28 REDINGTON ROAD LONDON NW3 7RB

Review of planning application 2016/2997/P to Camden Council with respect to 26 Redington Road and Camden development policy DP27.

Report reference G1615-RP-01-E1

SKETCHED APPROXIMATE BOUNDARY SECTIONS

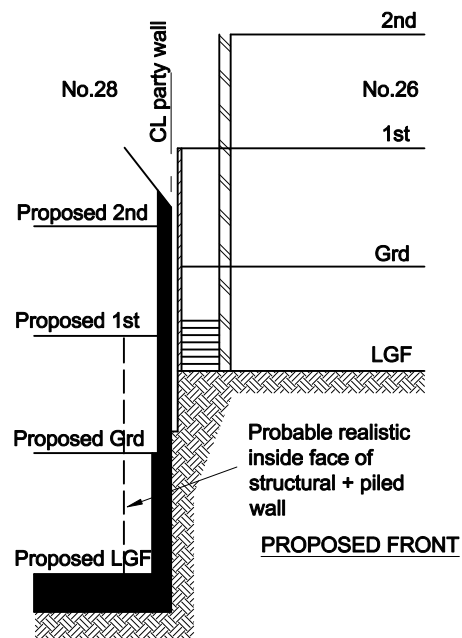
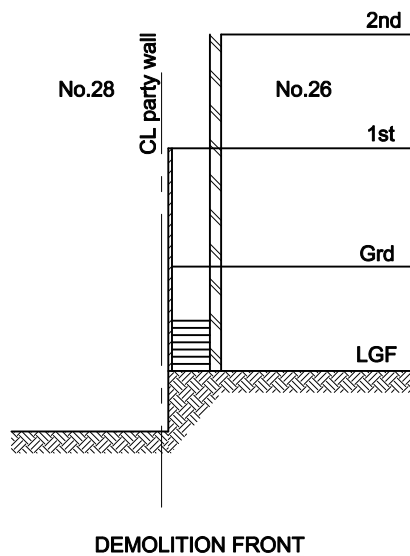
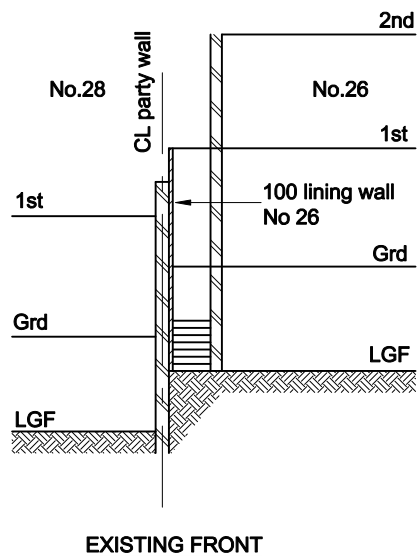
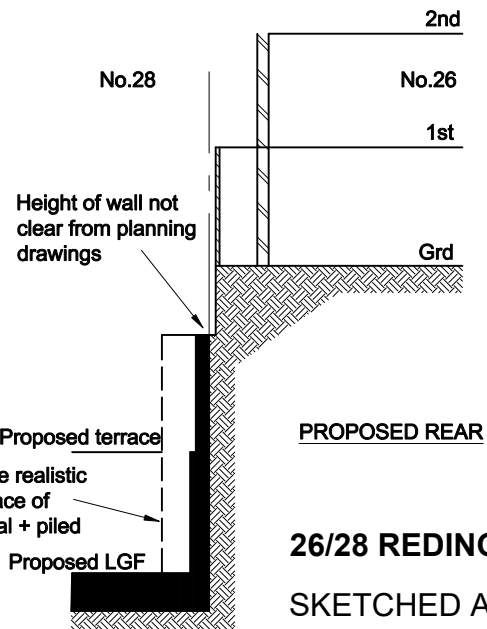
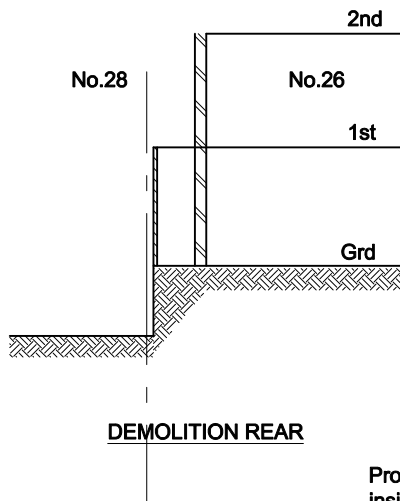
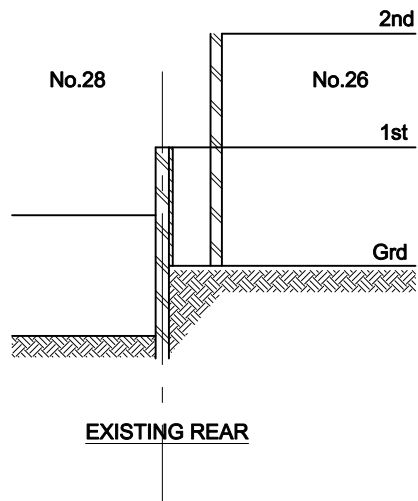
- 30. Figure 1 is in Appendix A.
- 31. The figure illustrates 3 situations at the boundary between Nos.26 and 30; existing, demolition and proposed. Two cases are considered, one near the front of the properties and one at the rear.
- 32. At present, according to the various drawings the boundary wall is astride the property boundary and thus a party wall. 2013/5996/P proposals, which have since been constructed, suggest that a 100mm thick lining wall was built against the party wall. No 26 has lower ground floor rooms in its front left part with stairs rising from these to the ground floor between the original external house wall and the lined party wall.

- 33. Architect's drawings for No 28 show an intention to demolish the existing party wall. Supposing that this could be done without disturbing the lining wall – I have no knowledge of its construction or the method by which it is supported – the 100mm wall remaining would be at considerable risk of being sucked out and demolished in the event of gale force winds. What is more likely is that the thinner wall was lightly tied to the party wall in some way during its construction and that attempts to demolish the much thicker party wall would take the lining wall with it and render parts of No.26 dangerous and uninhabitable.

- 34. Following demolition, the Architect for No.28 proposes to build the retaining wall for No.28 entirely upon the No.28 side of the boundary. As currently intended that would leave a gap between the new wall and the lining wall of No.26 and, at the rear, as far as can be estimated from the drawings, the lining wall is likely to be left exposed above a low terrace in No.28.

- 35. It would probably be argued that none of these situations are intended and that, of course, they would never be allowed to develop. But the fact is that these situations are those for which the developer is currently seeking planning consent.
- 36. The risk of severe damage to No.26 from these features of the application, is currently real and yet further example of the scheme's failure to satisfy DP27(a); this time in a way not contemplated by the BIA risk register.

37. The form of the retaining wall proposed by the Architect is illustrated by the solid black profiles in Figure 1. At the front of the property it would have to support nearly 2 storey heights of ground below No.26; from the top of the stairs in No.26 to the back of the house, there would be nearly 3 storeys of ground and the building above to support.

38. Construction of the wall shown by the Architect would require the whole of the basement to be excavated in stages with earth sides shored so that the walls could be constructed from the bottom up. The procedure would require a complex sequence of lateral support wherein supports would be frequently repositioned to allow the construction of the wall and floors to progress upward.

39. Even in good ground free of slope instability and high groundwater hazard, the expected outcome would be excessive ground movement and damage of No.26. The ground conditions as interpreted by Dr de Freitas could increase the health and safety hazard for work people to a dangerous level. Designers as well as contractors would need to consider their duties under HSE regulations.

40. The BIA refers to the use of a secant pile wall around the perimeter of the excavation. This would be the normal form of construction in the circumstances but the piles would have to be set in from the boundary sufficiently to provide safe working conditions. The distance varies according to the type and size of pile and the contractor employed. Broken lines on Figure 1 show what might be a reasonably indicative inset of the perimeter wall.

41. As presented the Architect's drawings depict a form of retaining wall construction with a high risk of causing excessive damage to No.26. that could not be ameliorated without change of design. The scheme again fails to satisfy DP27(a)
